# Technical Bulletin

TB: US201502RA

**Subject:** Correct Motor Identification**Models:** Turbofan Models E32D5

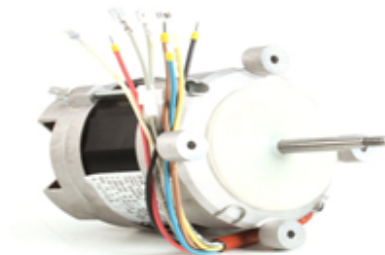
**Description of Change:** It has come to our attention that incorrect motors are being ordered for replacement. The following is meant as a clarification of the proper motor to be ordered based on the serial number of the machine and motor characteristics.

**M237548** – Kit for any E32D5 up to serial number 706748 which only has 4 wires

If the machine already has a motor with 7 wires and this connector they can replace just the motor with the M237335.

**M235625** - For any E32D5 from 708232 – 759468 this motor has 8 wires and is manufactured by Fir.

**M237335** - For any E32D5 from 759469.  
This is a Hanning motor with 7 wires.
